HISTORIC AND DESIGN REVIEW COMMISSION

December 20, 2017

HDRC CASE NO: 2017-660
ADDRESS: 231 E Houston
LEGAL DESCRIPTION: NCB 407 BLK 17 LOT E 93.51 FT OF 19 COURT BUILDING SUBD
ZONING: D, HS
CITY COUNCIL DIST.: 1
LANDMARK: George Building
APPLICANT: Peter French/Gray Street
OWNER: Gray Street Houston-219 E Houston Street LLC
TYPE OF WORK: Removal of glass storefront
APPLICATION RECEIVED: December 6, 2017
60-DAY REVIEW: February 4, 2018
REQUEST:

The applicant is requesting a Certificate of Appropriateness for approval to remove the glass storefront from 231 E Houston to create a covered area consistent with that of 229 E Houston.

EXTERIOR ELEVATIONS

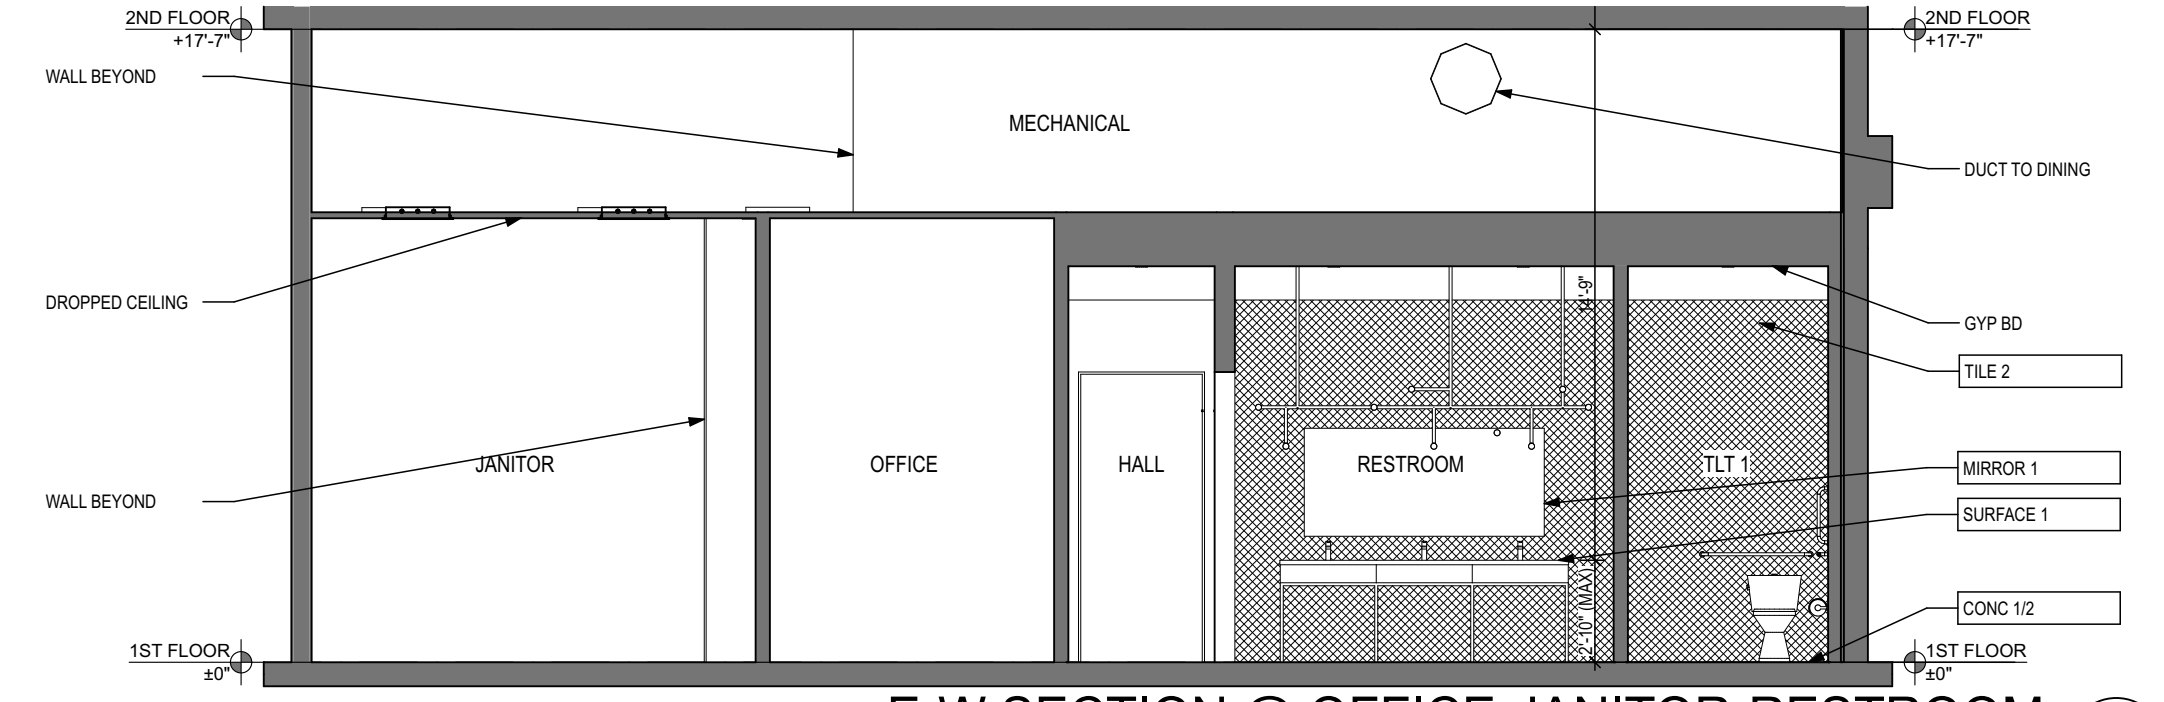
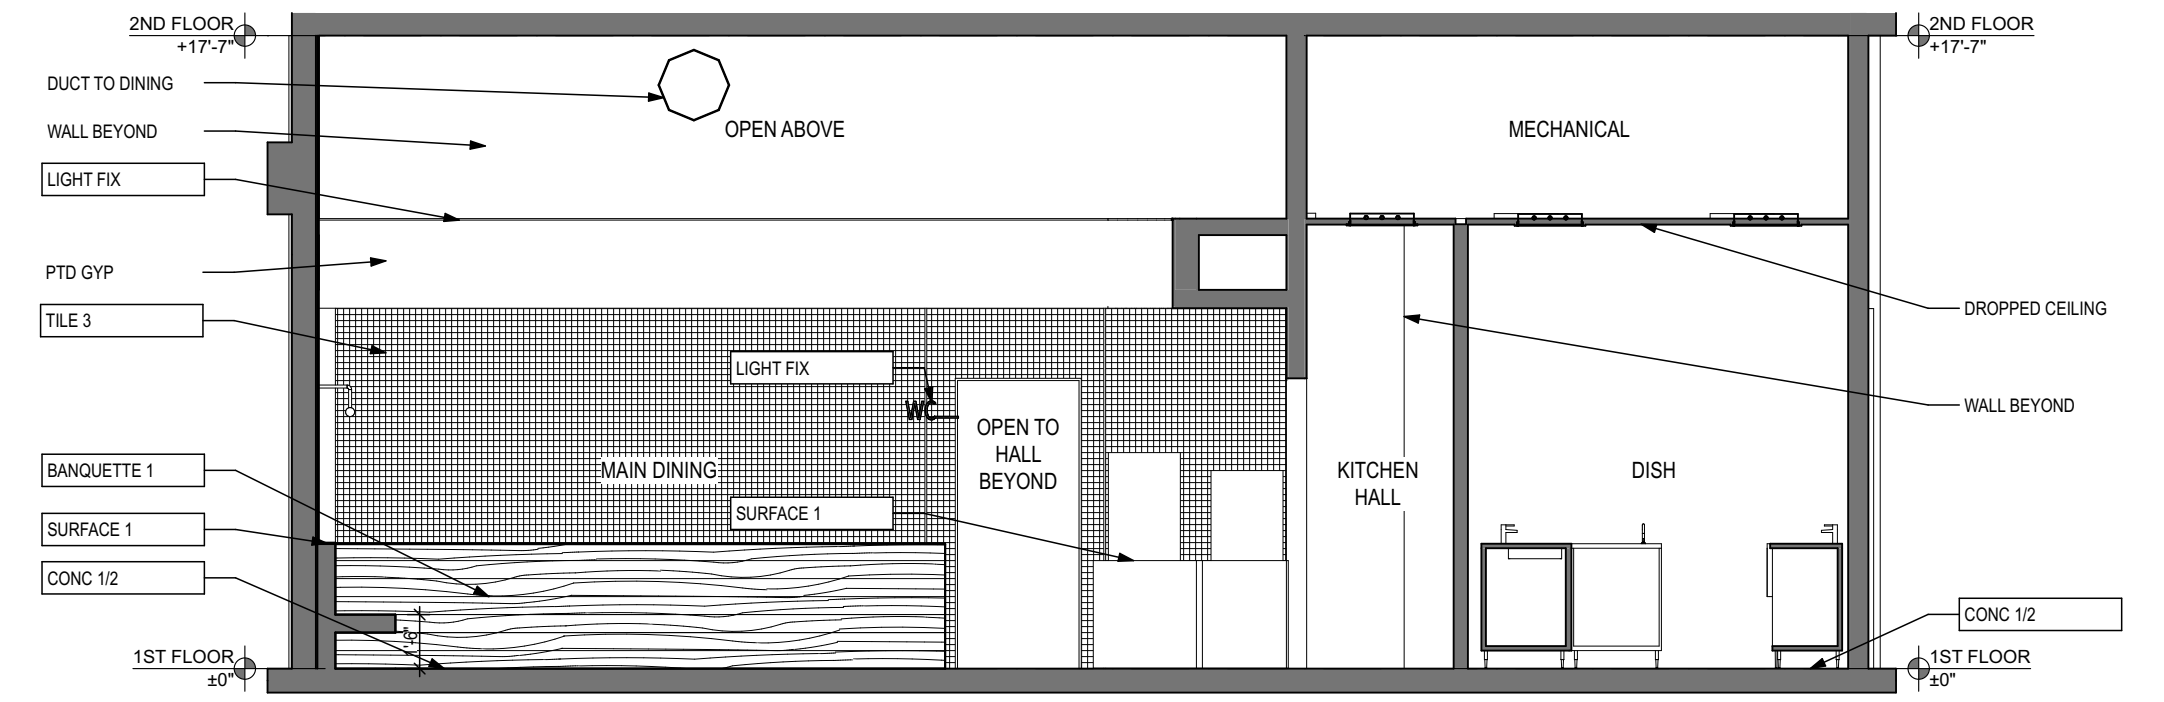
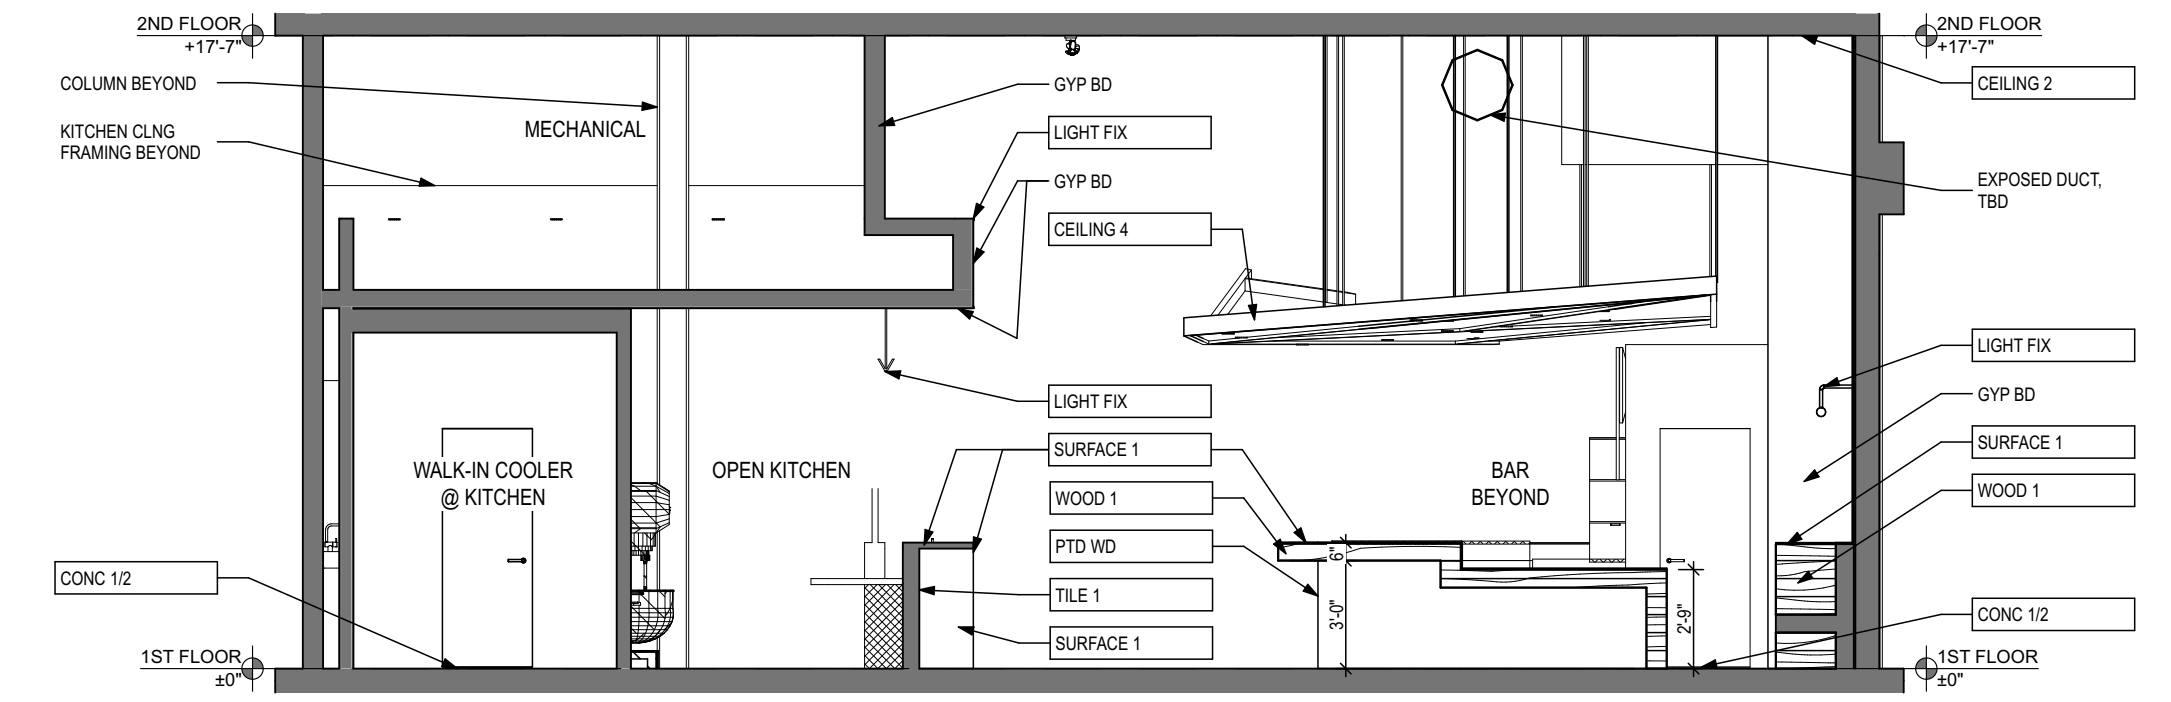
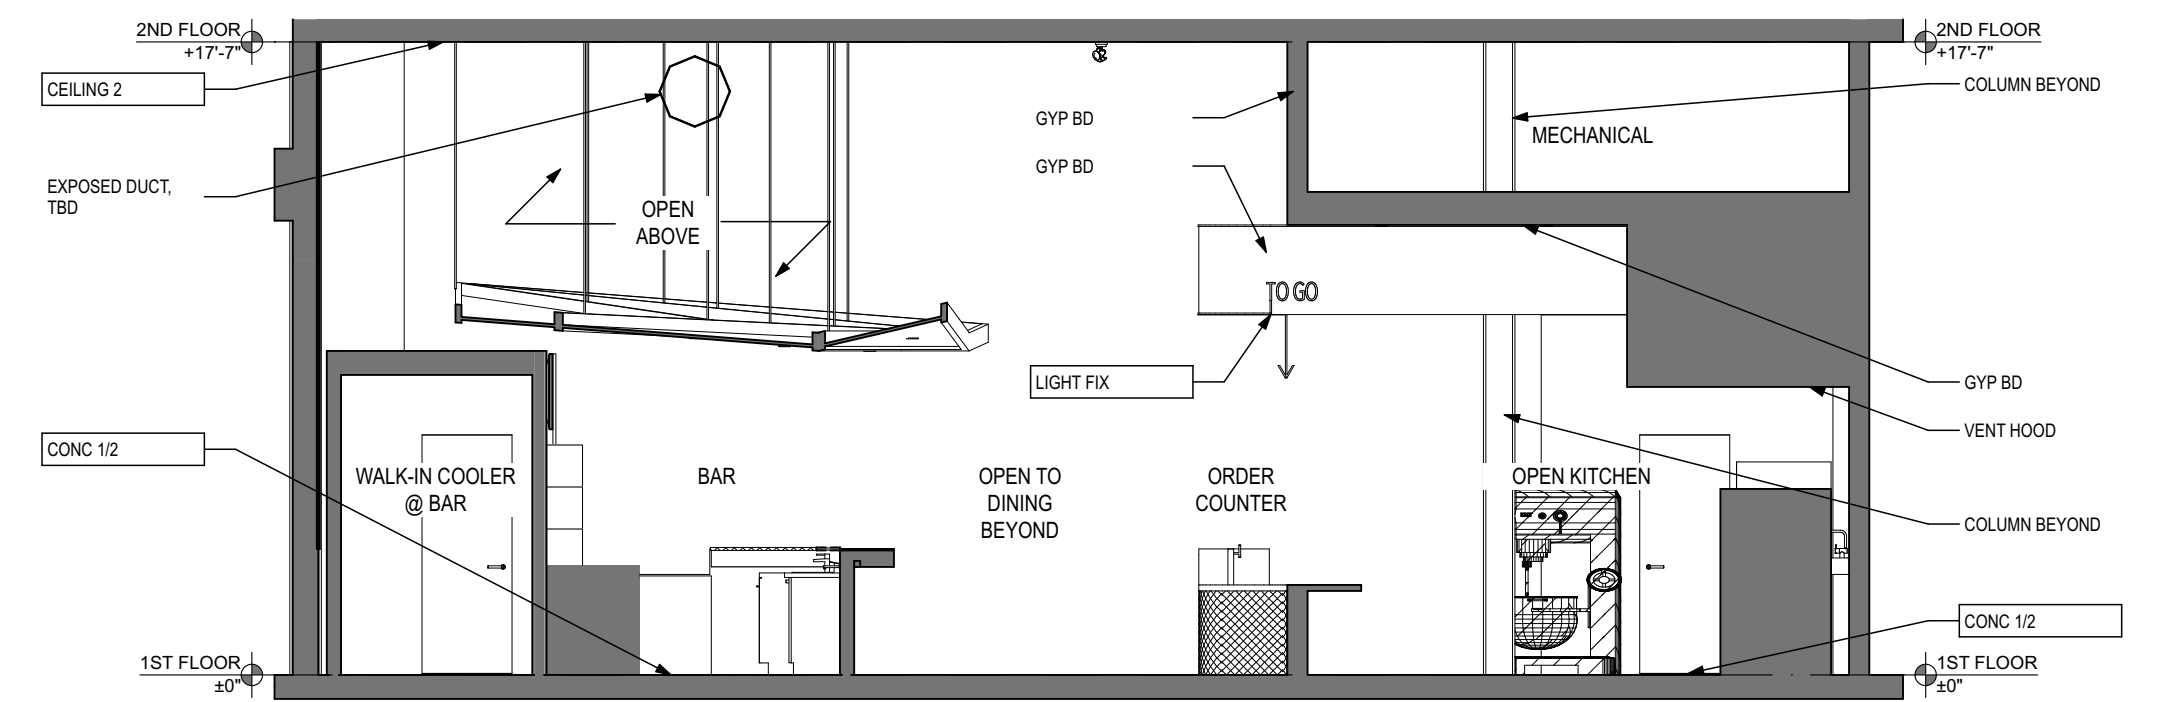
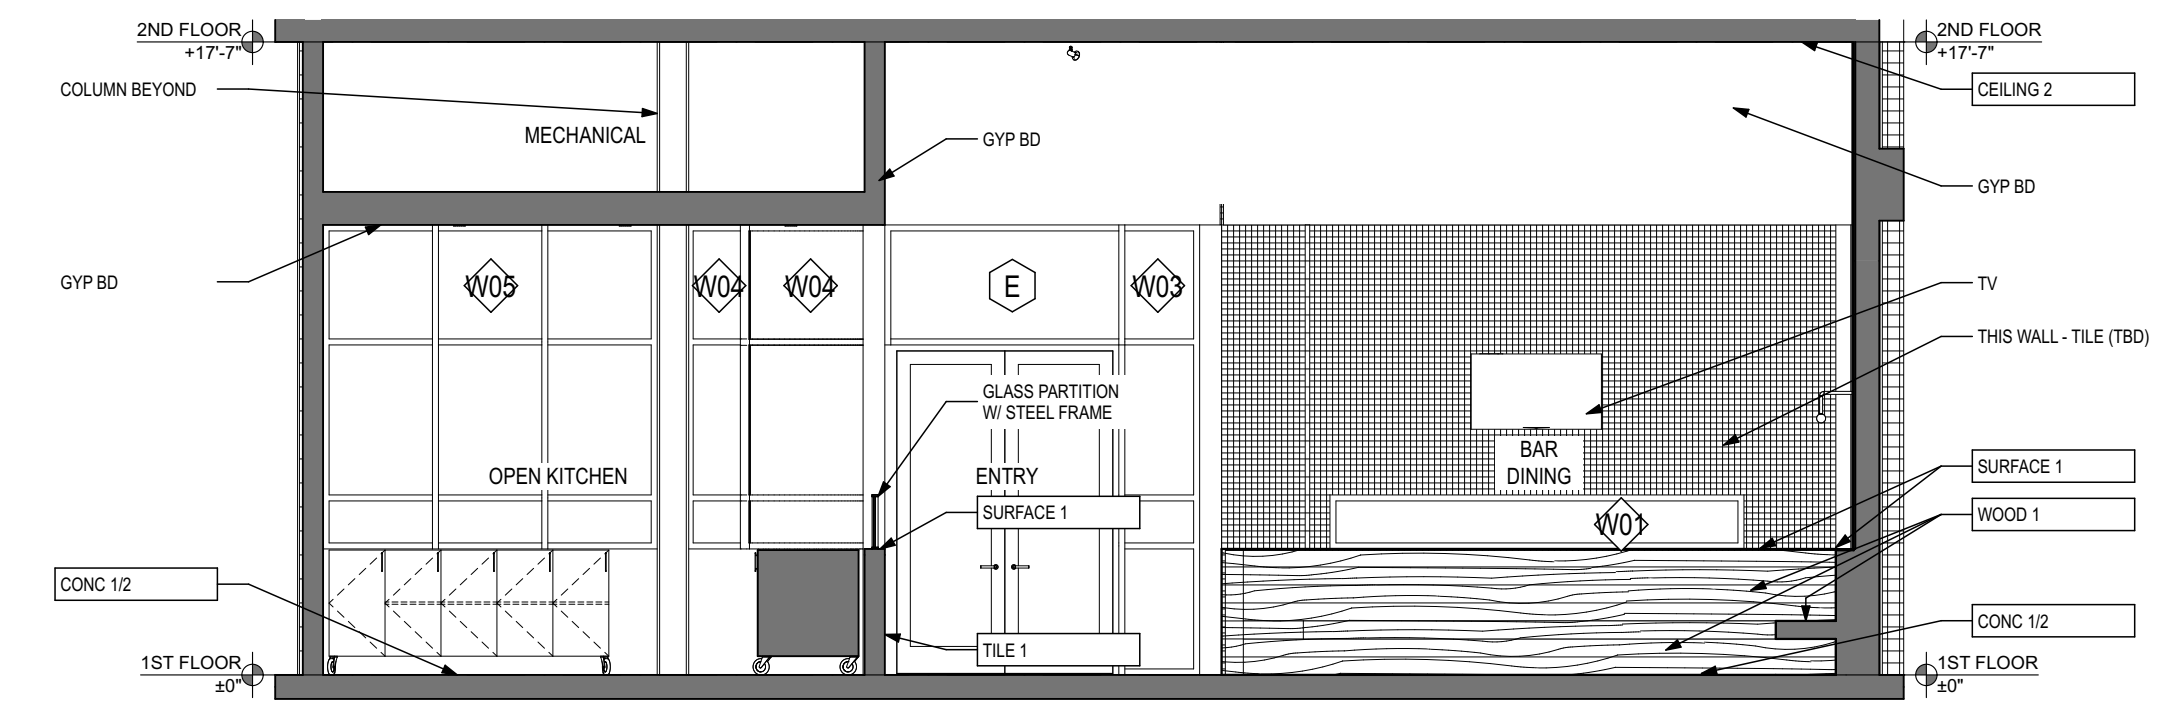
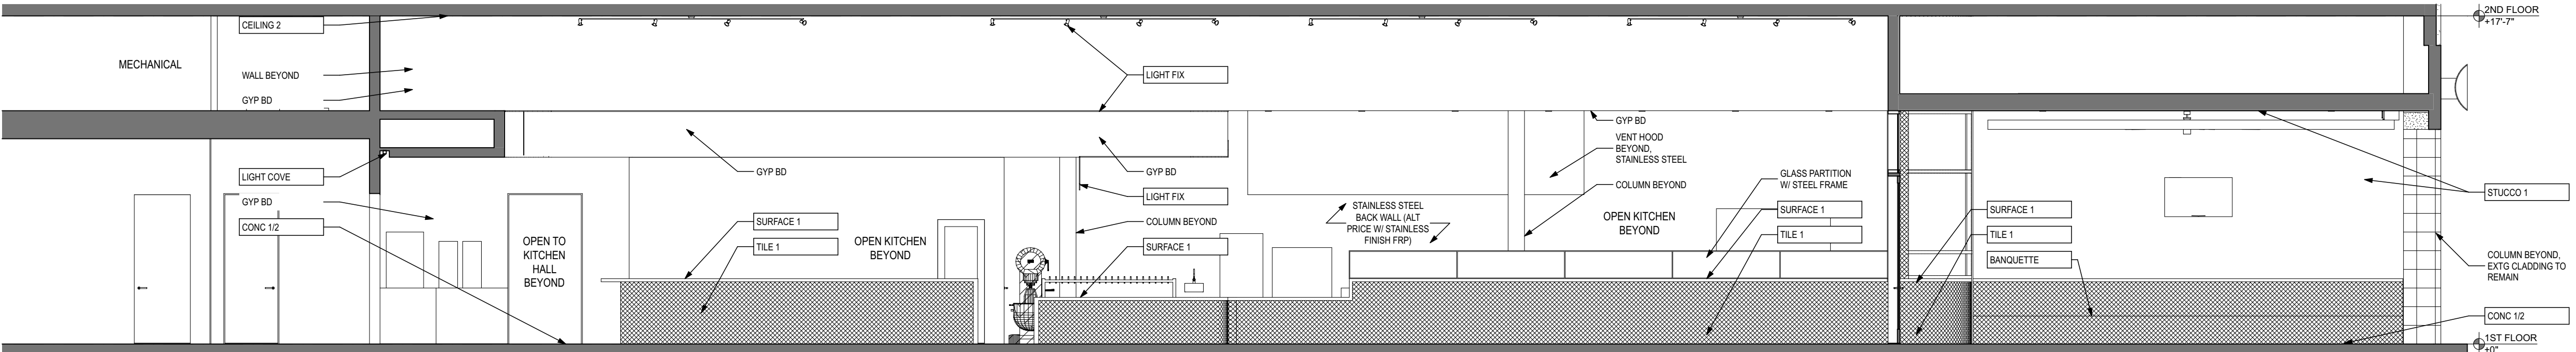
- a. The applicant is requesting a Certificate of Appropriateness for approval to remove the glass storefront from 231 E Houston to create a covered area consistent with that of 229 E Houston. The Guidelines for Exterior Maintenance and Alterations 10.A.i. notes that character defining features of historic facades should be retained. Additionally, the Guidelines for Exterior Maintenance and Alterations 10.B.ii. notes that some non-original façade elements may have gained historic significance and should be retained. Staff finds the existing storefront and façade materials to not be original to the structure and their removal to be appropriate. Final material details and site furnishings are to be submitted to staff for review and approval.

Staff recommends approval based on finding a.
